Objection to Glebe Island and White Bay Advertising Signage DA 21/13182

Save Our Bays has strong objections, as outlined here, to the application by Eye Drive Sydney to ‘extend the duration of the use of the Glebe Island Silos signage display for a ten (10) year term with external illumination from dusk to 1am.”

Photo 2: View 13 – Actual impact from residence 28/501 Glebe Point Road Glebe (25 March 2018)

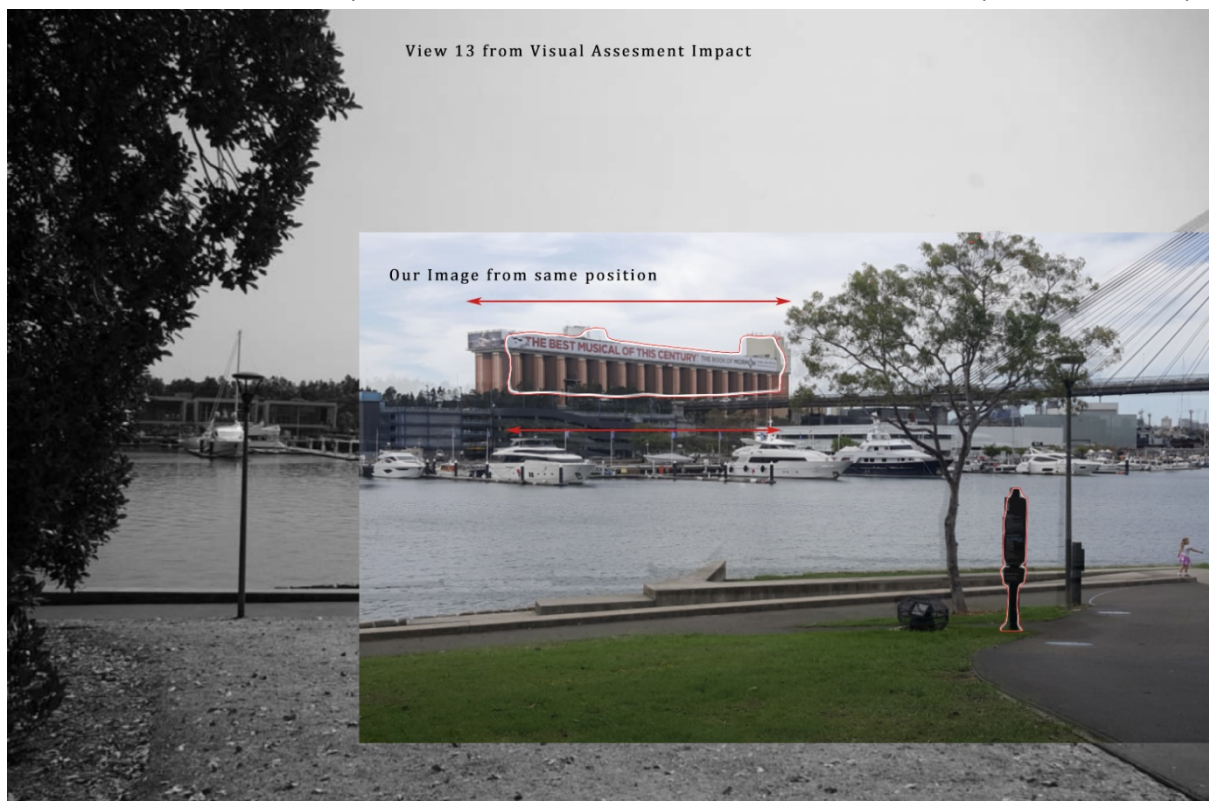
These “assessments” are strikingly at odds with a reasonable and honest assessment of the impact at one of the closest residential locations and clear views of the silos and the advertising from the Glebe foreshore walkway near View 13 – as the facts and photos shown below indicate.

The signage at View 13 is *not* at a significant distance – at about 450 m³ and there is little or no visual distraction or screening by foreshore tree planting.

3. The photos presented by GroupGSA do not present an accurate representation of the distance and impact. They clearly minimise the size and visual impact of the advertising.
